SUBJECT: AMENDMENT NO. 48 TO FACILITY OPERATING LICENSE NO. NPF-62  
(TAC NO. 73800)

CLINTON POWER STATION, UNIT NO. 1

AMENDMENT TO FACILITY OPERATING LICENSE

SAFETY EVALUATION BY THE OFFICE OF NUCLEAR REACTOR REGULATION  
RELATED TO AMENDMENT NO. 48 TO FACILITY OPERATING LICENSE NO. NPF-62  
ILLINOIS POWER COMPANY, ET AL.  
CLINTON POWER STATION, UNIT NO. 1  
DOCKET NO. 50-461

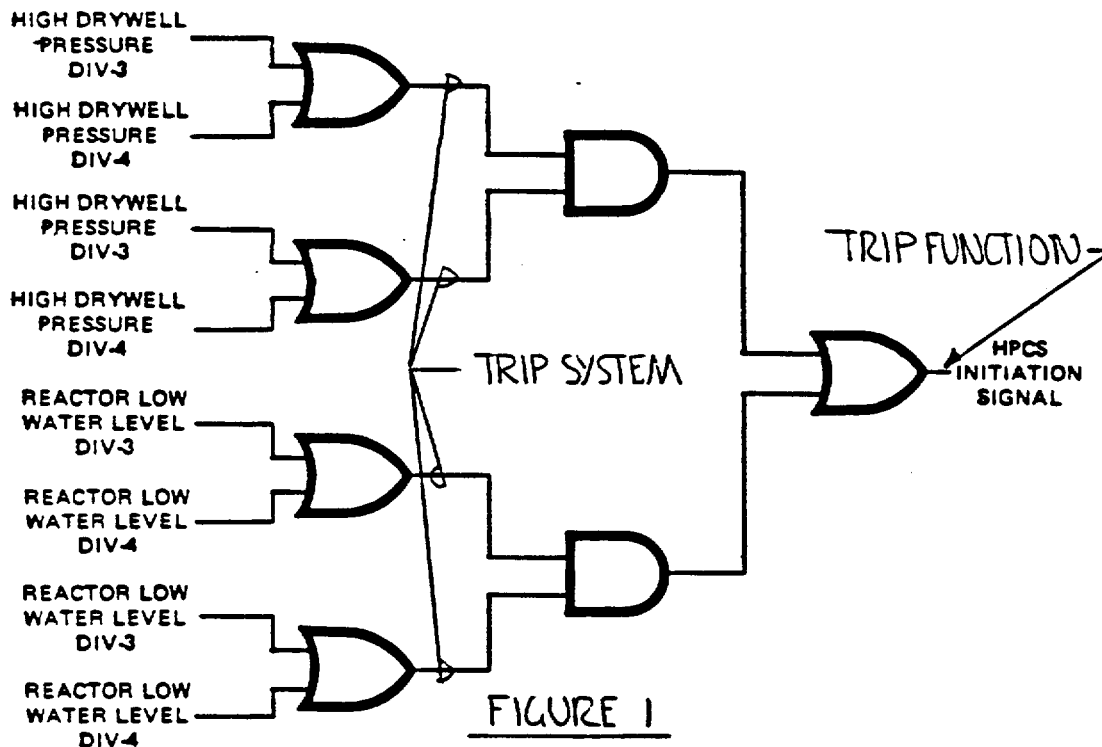
The purpose of the second change of this amendment is to clarify the one-out-of-two taken twice logic arrangement and the Minimum Operable Channels Per Trip System requirements of the reactor water level and high drywell pressure channels inputs to the HPCS and CRVICS. These changes clarify the trip system boundary for the four reactor water level and high drywell pressure inputs to the HPCS (CRVICS) as shown in Figure 1. The

change proposed by the licensee involves adding notes "m" and "n" to Table 3.3.2.1 and notes "e" and "f" to Table 3.3.3-1. These notes ensure that the corresponding action statements are implemented properly when one or more channels are declared inoperable. The staff reviewed the proposal and determined that defining the trip system as shown on the licensee's submittal is acceptable.
